Event Bulletin 01 - Technical

GLOBAL ROTAX MAX Challenge Technical Regulation 2024

Valid from: 2024 April 08

Addendum/changes (highlighted in yellow) to Global RMC Technical Regulation 2024, Edition 2023 11 13 Version 2

6.17 125 MICRO MAX

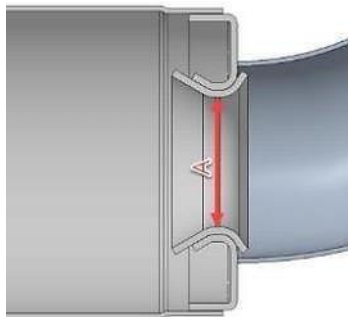
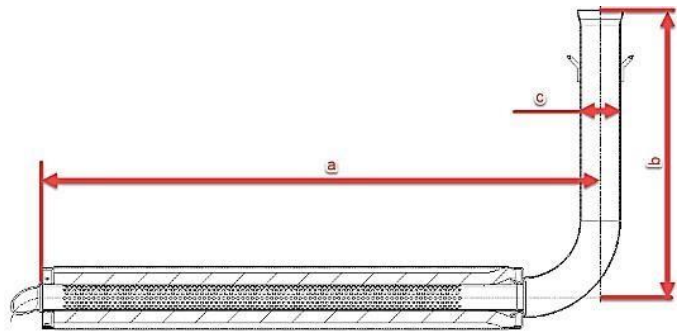
A specific Exhaust system has to be used for the 125 Micro MAX engine. ROTAX Part number 273136

The Exhaust external body is a common component to Mini MAX, but with alternative internal components (Inserts).

The silencer must be mounted in a Position where the direction of the 90° elbow outlet (direction of the hot exhaust gasses) does not harm any component of the chassis.

The exhaust must be mounted and secured in such a way to ensure a full sealing around the exhaust socket and the gasket ring.

The measurements in the diagram to the right are as follows:

- (a) 580 mm +/- 5mm
- (b) 299 mm +/- 5mm
- (c) 42 mm +/- 3mm

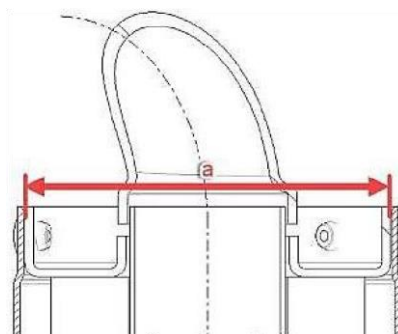
A solid flat plate measuring 28.0mm and 1.5mm thick **must not** pass through Section "A" and

a steel ball with a 26.0mm diameter must be able pass through Section "A" in the below diagram from the inlet and through the 90- degree elbow completely. All exhaust gases must pass through Section "A".

(Internal exhaust components must first be removed)

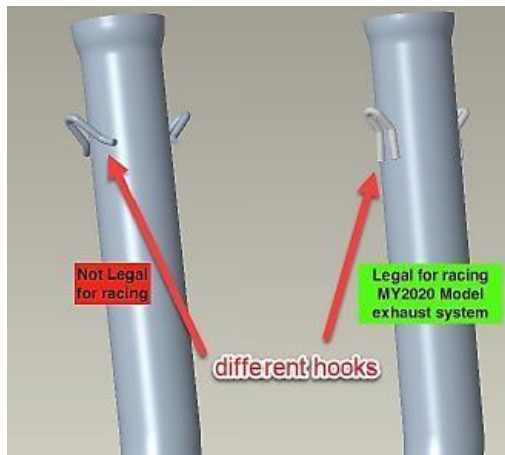
The only exhaust system allowed for racing in the 125 Micro and 125 Mini MAX category's is the MY2020 version.

The exhaust has 3 clear visual differences to identify the MY2020 version.

1. Exhaust hooks
2. Connecting socket / ball joint connect at manifold
3. Wall thickness of the exhaust system is 1.0mm (older exhaust system which is not allowed for racing has a wall thickness of 1.5mm)

6.17 125 MINI MAX

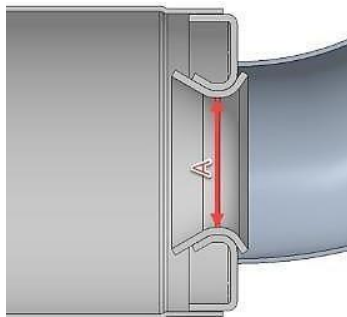
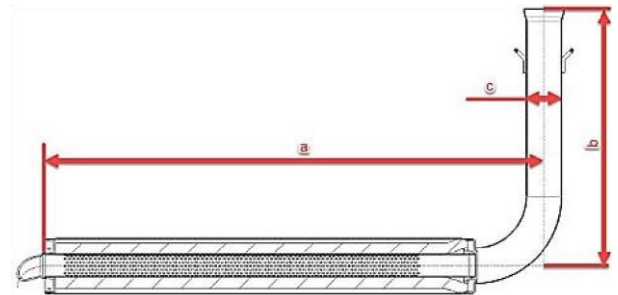
A specific Exhaust system has to be used for the 125 Mini MAX engine. ROTAX Part number 273137

The Exhaust external body is a common component to Micro MAX but with alternative internal components.

The silencer must be mounted in a Position where the direction of the 90° elbow outlet (**direction of the hot exhaust gasses**) does not harm any component of the chassis.

The exhaust must be mounted and secured in such a way to ensure a full sealing around the exhaust socket and the gasket ring.

The measurements in the diagram below are as follows:

- (a) 580 mm +/- 5mm
- (b) 299 mm +/- 5mm
- (c) 42 mm +/- 3mm

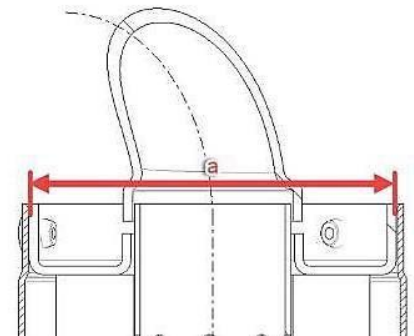
A solid flat plate measuring 28.0mm and 1.5mm thick **must not** pass through Section "A" and

a steel ball with 26.0mm diameter must be able pass through Section "A" in the below diagram from the inlet and through the 90-degree elbow completely. All exhaust gases must pass through Section "A".

(Internal exhaust components must first be removed)
